Studebaker

SERVICE BULLETIN

NO. 314

1956

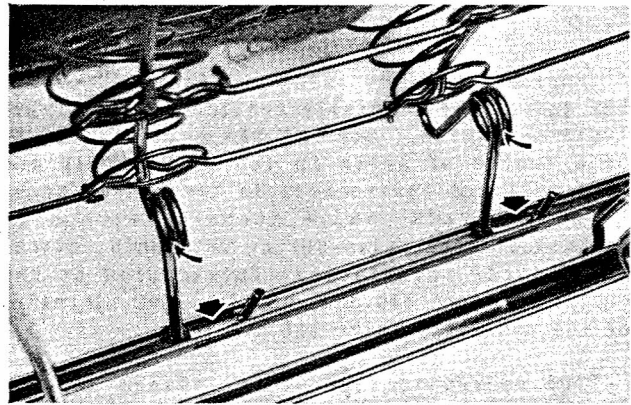
A new spring shackle 3-1/2" long for the left rear spring has been released for production and service. This longer shackle will help maintain a level condition, compensating for the additional weight of the left side of the car.

The new shackle may be obtained by ordering from your Parts Depot under Part No. 529168.

FIG. 3

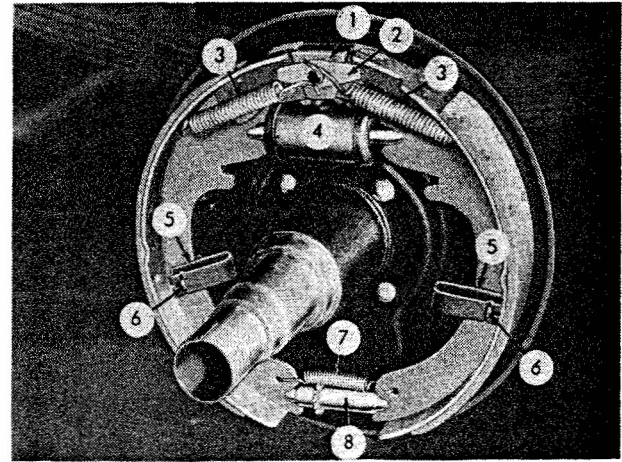
To improve the product and to provide for the use of tubeless tires, changes have been made in front axle steering knuckles, brake assemblies, hub and drum assemblies, and wheels.

A Wagner self-energizing type brake with a star wheel adjustment between the lower ends of

the shoes is now being used. The front brake has the single piston in the wheel cylinder, the rear brake two pistons in the wheel cylinder. This is the same type brake used on the 2E13 model (see Figs. 3 and 4). Servicing procedures are the same as described for the 2E13 model.
